UNITED STATES
NUCLEAR REGULATORY COMMISSION
WASHINGTON, D.C. 20555-0001

SAFETY EVALUATION BY THE OFFICE OF NUCLEAR REACTOR REGULATION

PALISADES: PRESSURE VESSEL FLUENCE REEVALUATION

CONSUMERS POWER COMPANY

Figure 5 Spectral Dependence of Capsule Flux

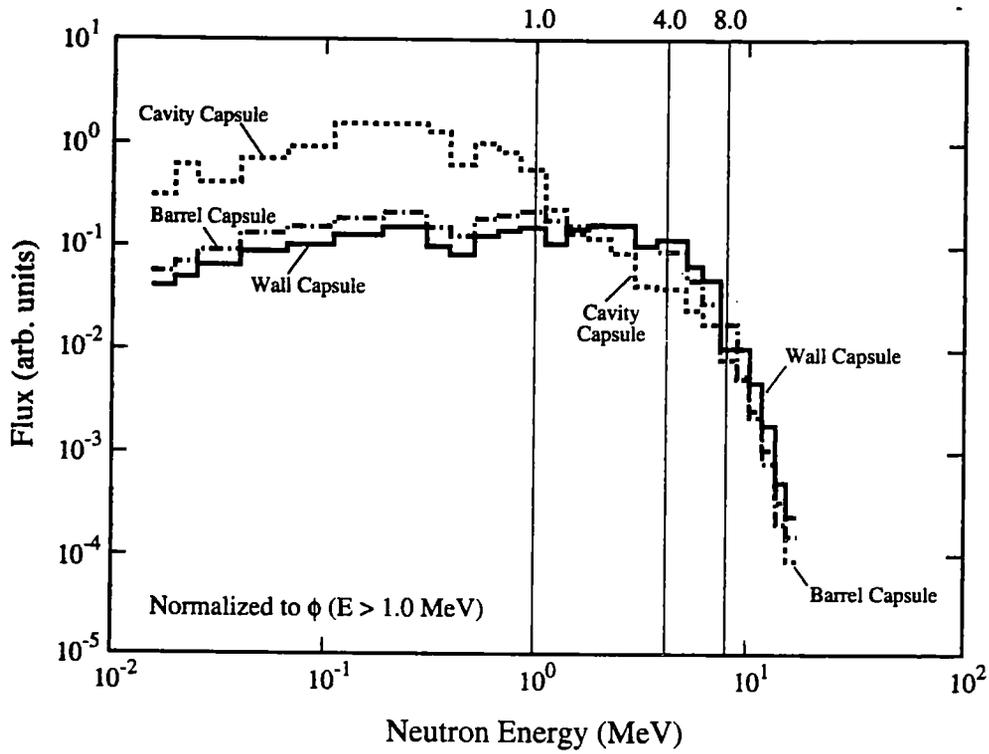
The M/C bias indicates a significant dependence on the location of the dosimeters (cavity versus in-vessel) and on the energy threshold of the dosimeters ($E > 4.0$ MeV versus $E < 4.0$ MeV) as seen in Figures 3 and 4. In determining the measurement to calculation bias for the prediction of the inner wall vessel fluence, it is important to recognize the difference in the fluence spectrum at these two locations. In Figure 5, a comparison of the fluence spectrum at the location of the accelerated (barrel outer wall), the vessel inner wall and the cavity capsules is presented. It is evident from

this comparison that the fluence spectrum at the cavity capsule differs significantly from the spectrum at the vessel inner wall where the fluence prediction is required. This is due, in part, to the fact that Palisades does not have a thermal shield and the additional about 8 inches of steel between the inner wall and cavity locations. It is concluded that the M/C comparisons made for the in vessel dosimetry are a more accurate indication of the M/C comparisons made for the in vessel dosimetry are a more accurate indication of the M/C to be used for the in vessel fluence prediction.

Figure 6 Capsule Flux Adjustment

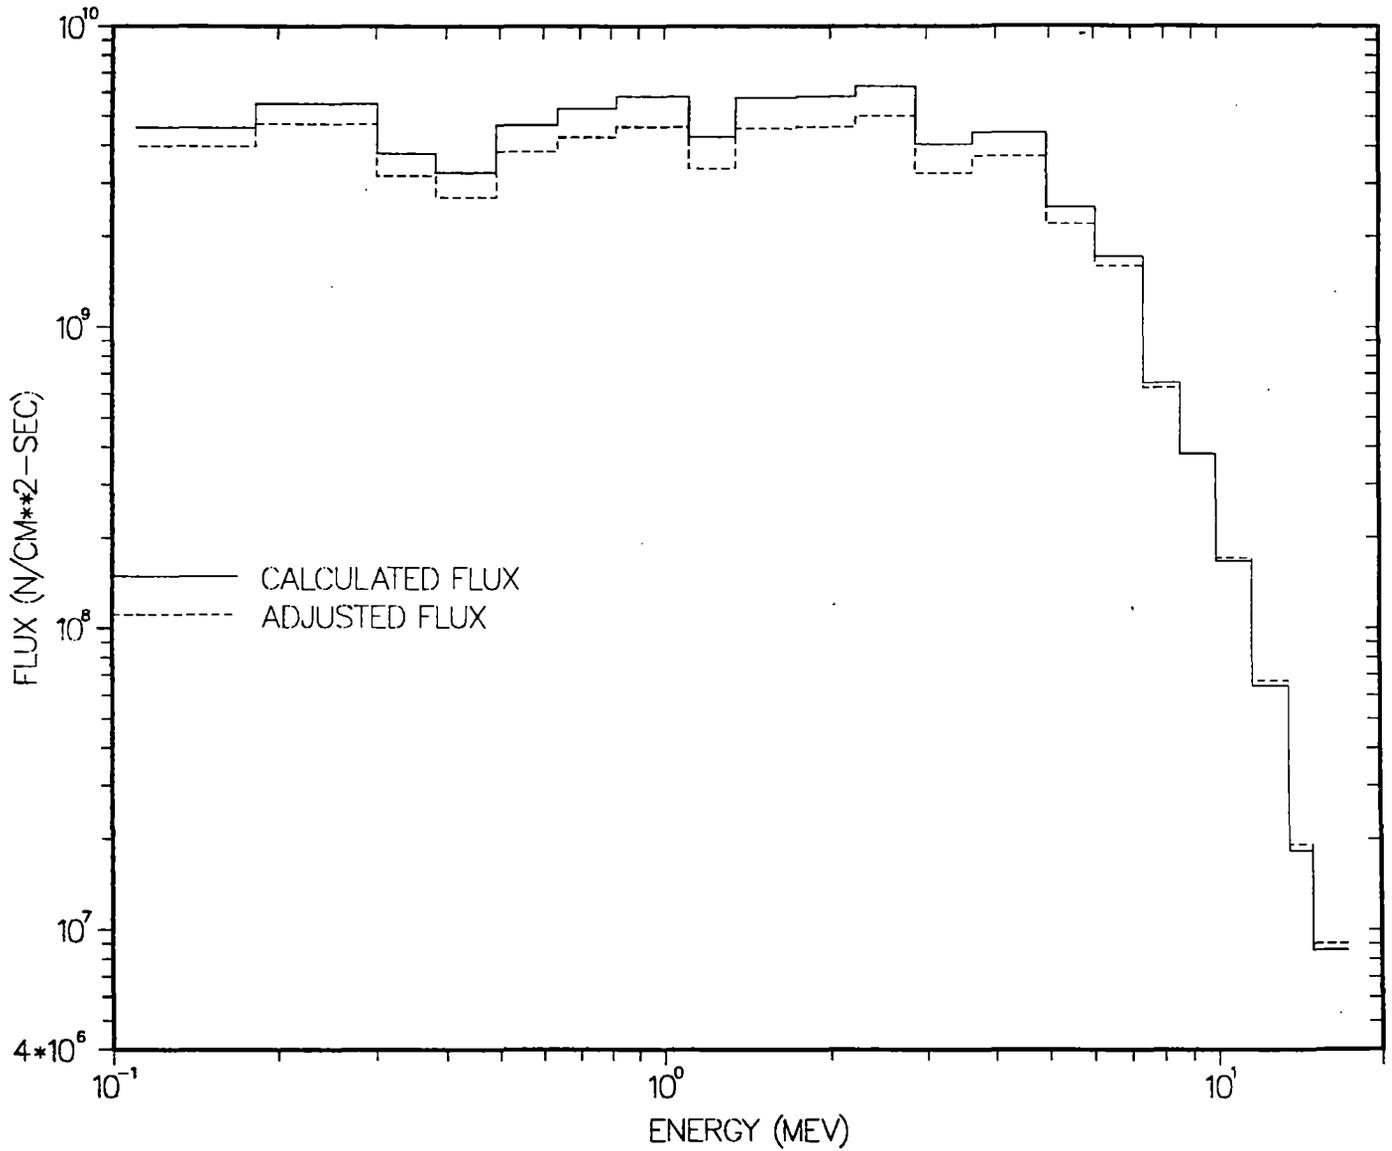
A major concern with the application of the FERRET adjustment is that, while the adjustment does provide a best fit of the measured data, the dosimeter cross sections, measured reaction rates and calculated spectrum adjustments are made without any physical basis. This application of the FERRET adjustment methodology to Palisades is presently being evaluated and the results of this evaluation will be reported separately when completed.

Figure 5 Spectral Dependence of Capsule Flux

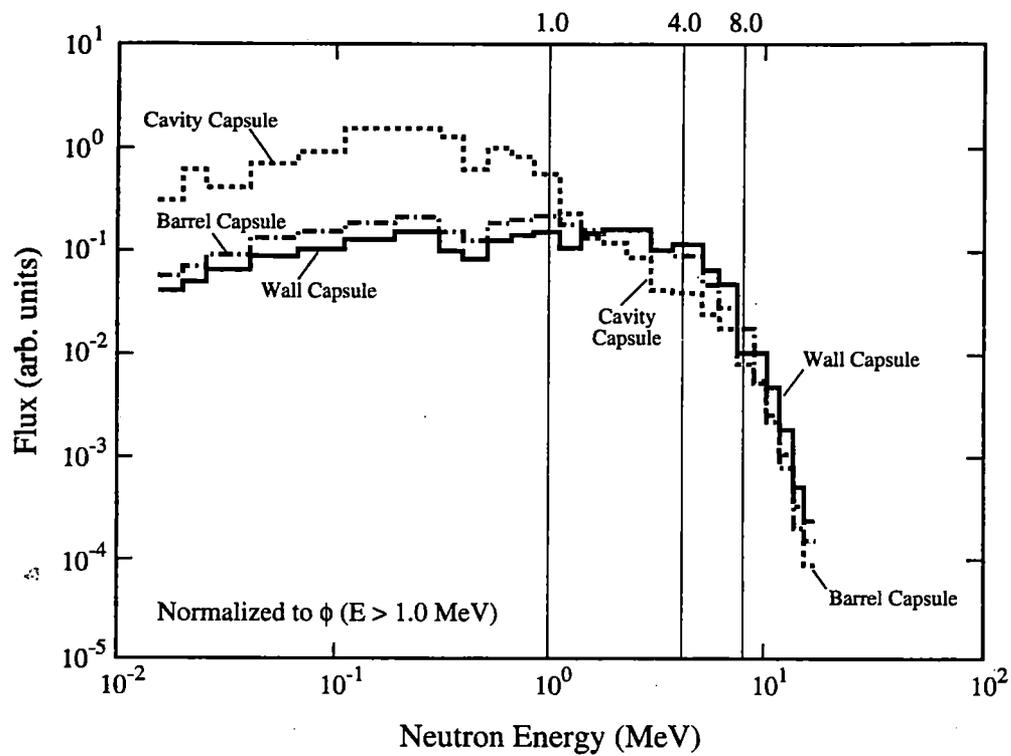
The M/C bias indicates a significant dependence on the location of the dosimeters (cavity versus in-vessel) and on the energy threshold of the dosimeters ($E > 4.0$ MeV versus $E < 4.0$ MeV) as seen in Figures 3 and 4. In determining the measurement-to-calculation bias for the prediction of the inner-wall vessel fluence, it is important to recognize the difference in the fluence spectrum at these two locations. In Figure-5, a comparison of the fluence spectrum at the location of the accelerated (barrel outer-wall), the vessel inner-wall and the cavity capsules is presented. It is evident from this comparison that the fluence spectrum at the cavity capsule differs significantly from the spectrum at the vessel inner-wall where the fluence prediction is required. This is due, in part, to

the fact that Palisades does not have a thermal shield and the additional ~8" of steel between the inner-wall and cavity locations. It is concluded that the M/C comparisons made for the in-vessel dosimetry are a more accurate indication of the M/C to be used for the in-vessel fluence prediction.

Figure 6 Capsule Flux Adjustment

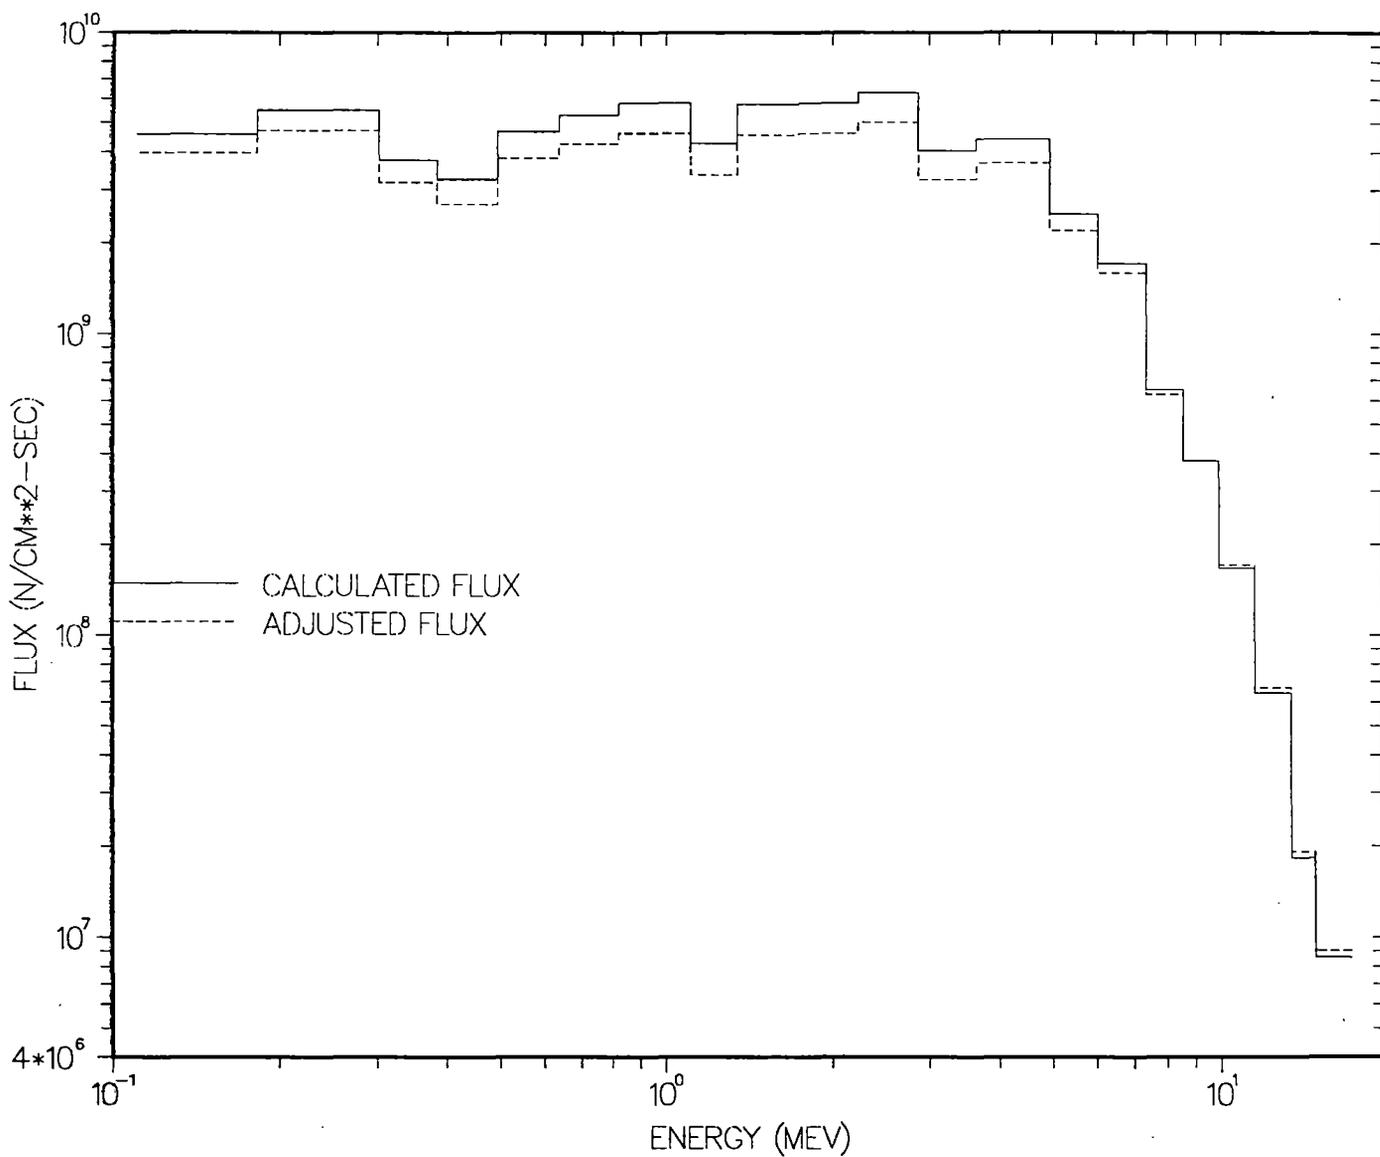
A major concern with the application of the FERRET adjustment is that, while the adjustment does provide a best-fit of the measured data, the dosimeter cross sections, measured reaction rates and calculated spectrum adjustments are made without any physical basis. This application of the FERRET adjustment methodology to Palisades is presently being evaluated and the results of this evaluation will be reported separately when completed.
